WEST ABQ SELF STORAGE

**Re: West ABQ Self Storage
99999 Woodmont NW (Paseo Del Norte & Woodmont)
Conceptual Traffic Circulation Layout for DFT Approval
Engineer's Stamp 8-1-25 (C09D022) TRANS-2025-00212**

**RE: West ABQ Self Storage
99999 Woodmont Ave NW
Conceptual Grading Plans
Engineer's Stamp Date: 8/1/25
Hydrology File: C09D022
Case # HYDR-2025-00273**

GRADING EXHIBIT

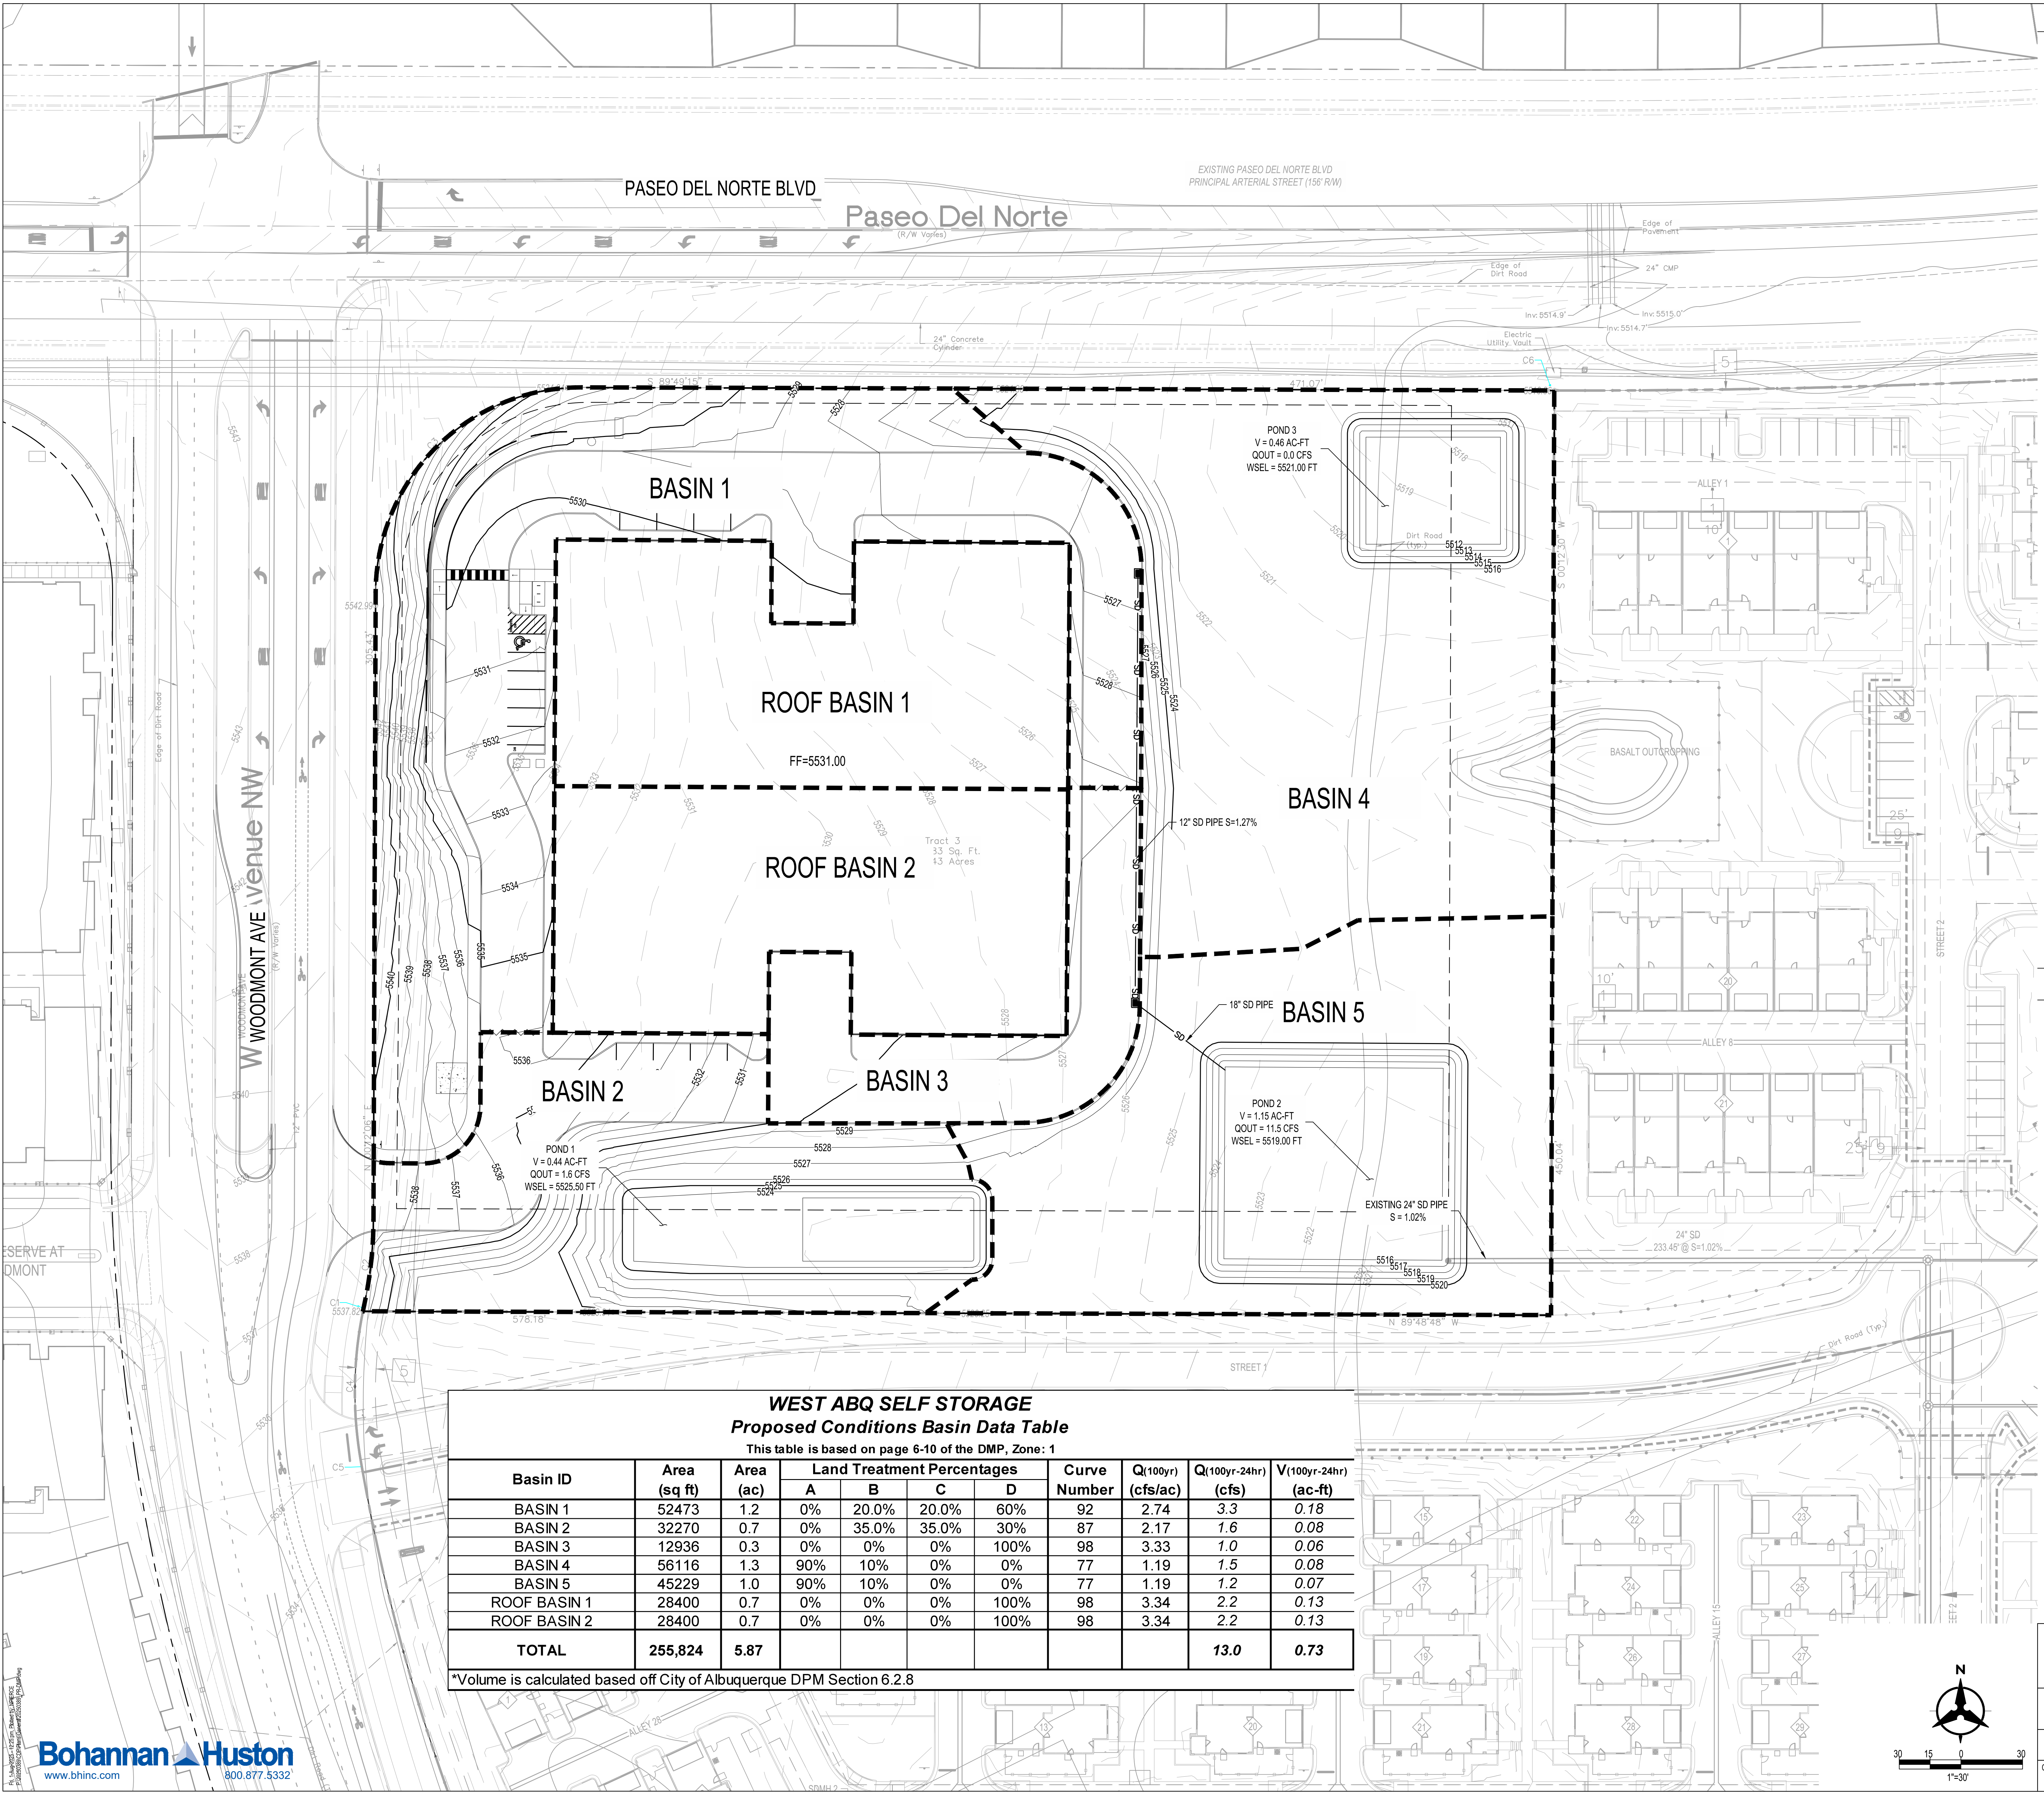
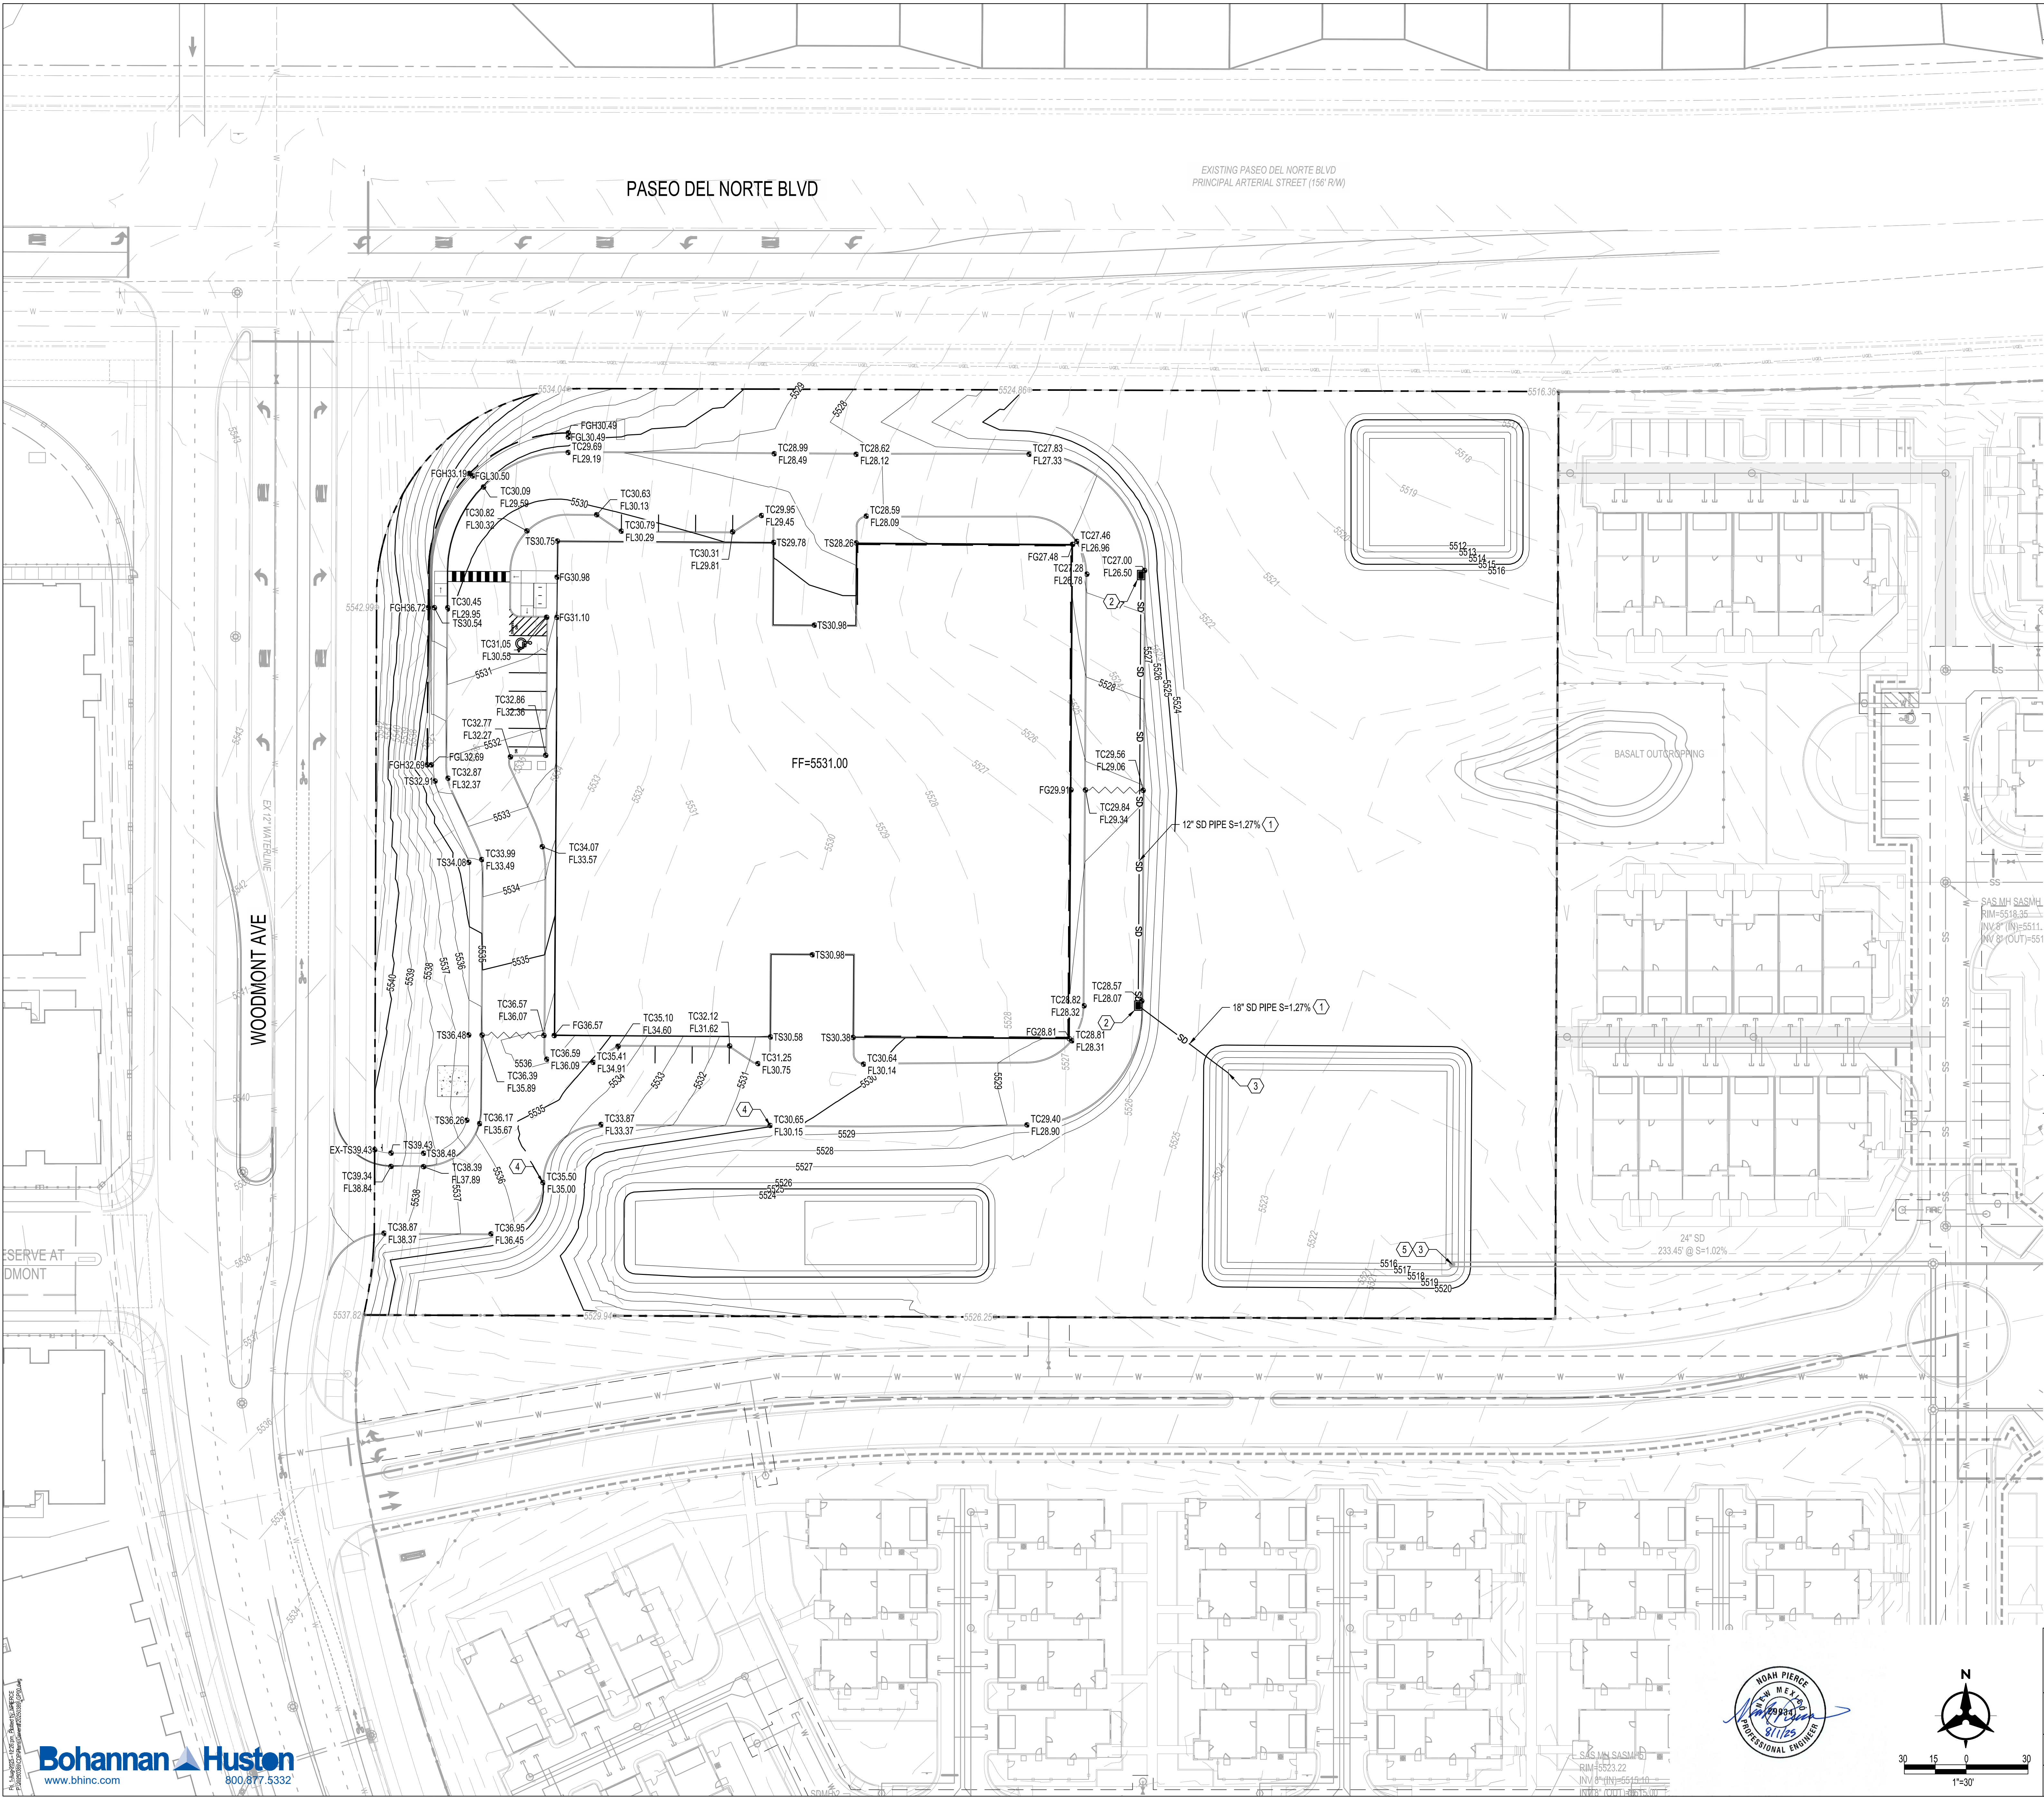
Based upon the information provided in your submittal received 08/01/2025, the Conceptual Grading Plans are preliminary approved for action by the Development Facilitation Team (DFT) on Site Plan for Building Permit.

1. Please submit the Grading Plans to Hydrology for review and approval.
2. Please provide the Drainage Covenant with Exhibit A for the stormwater quality ponds per Article 6-15(C) of the DPM. Please submit the original copies along with the **\$ 25.00** recording fee check made payable to Bernalillo County to the Hydrology Section of Development Review Services on the Ground floor of Plaza de Sol.
